PRELIMINARY DRAINAGE REPORT
for
FALCON MARKETPLACE

January 17, 2017
Revised: June 18, 2018

Drexel, Barrell & Co.
3 South Seventh Street
Colorado Springs, CO 80905
Contact: Tim McConnell, P.E.
(719) 260-0887

SPILLWAY CALCULATIONS

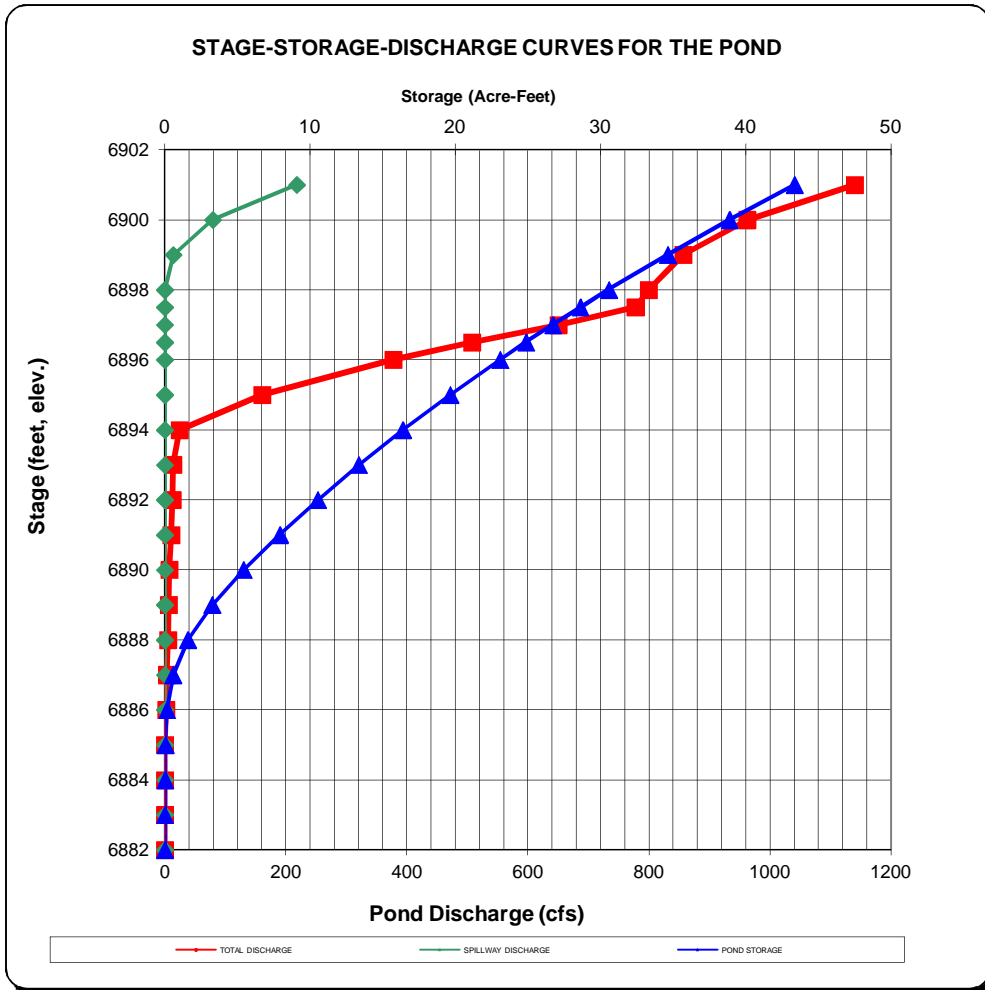
FALCON MARKETPLACE
 15-FT Head x 62-4 = 936 psf
 Verify compliance with flow velocity considerations for safety (<2.5 ft/sec.)
 Reference UDFCD vs. T-12/OS-3.

Isn't span 8'? (current plan). This does not match plan labels of standard grate.

Sheet 4-21

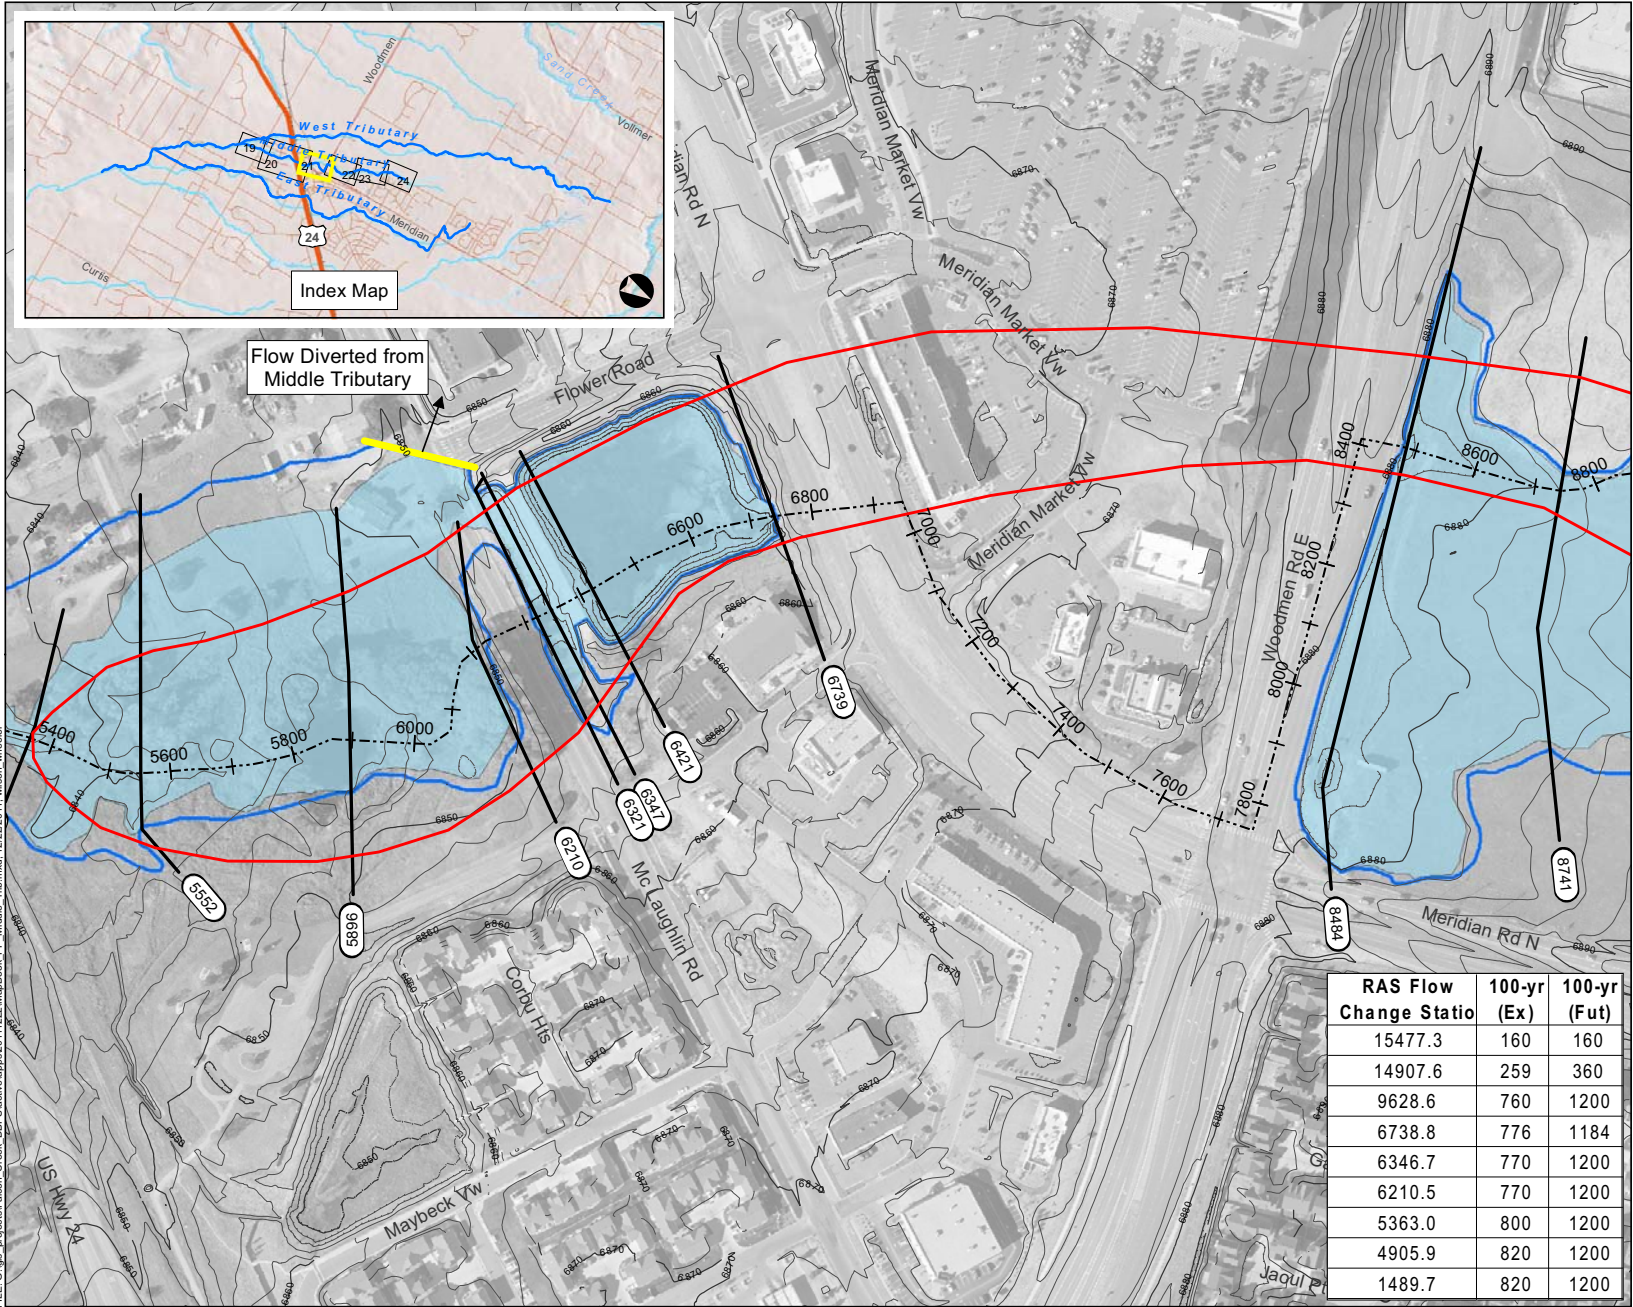
Provide peak flow table and Figure 5-3 and/or corrected Figure 6-1.

Verify Pond SR4 inlet covers this area or re-model.

ED-1
 SHEET: 1 OF 1

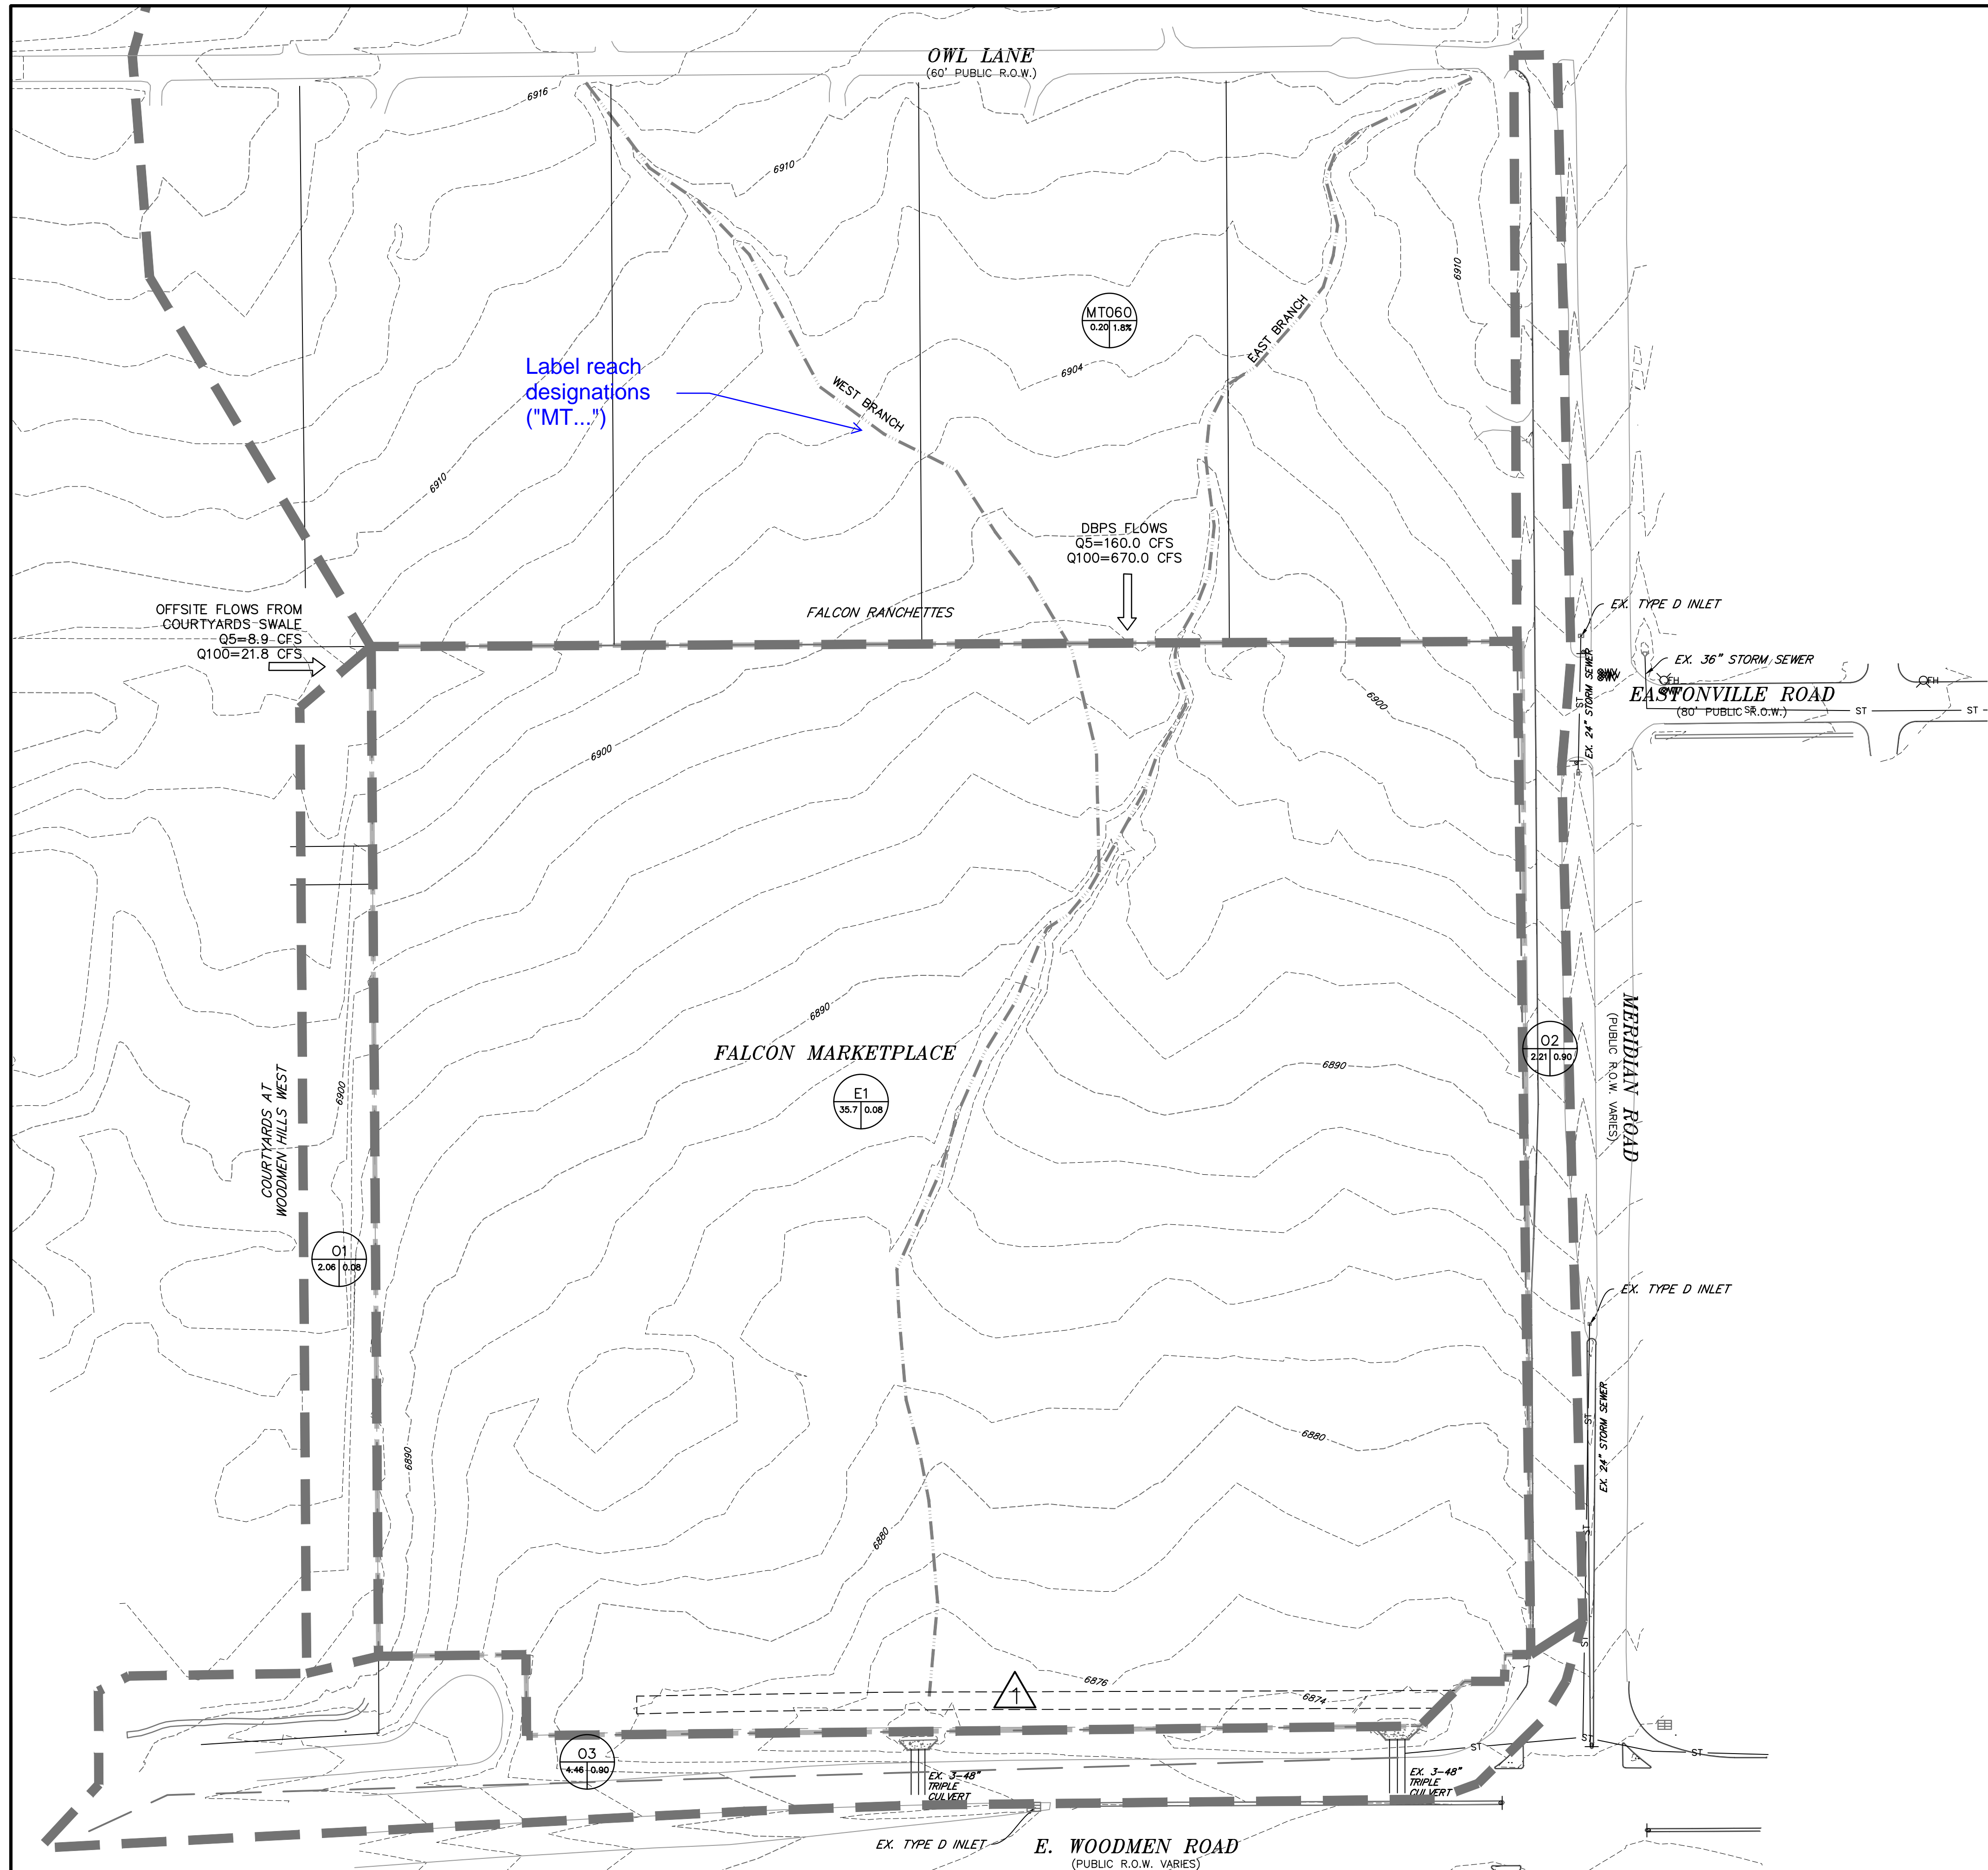
Show and label all offsite design points and sub-basins.
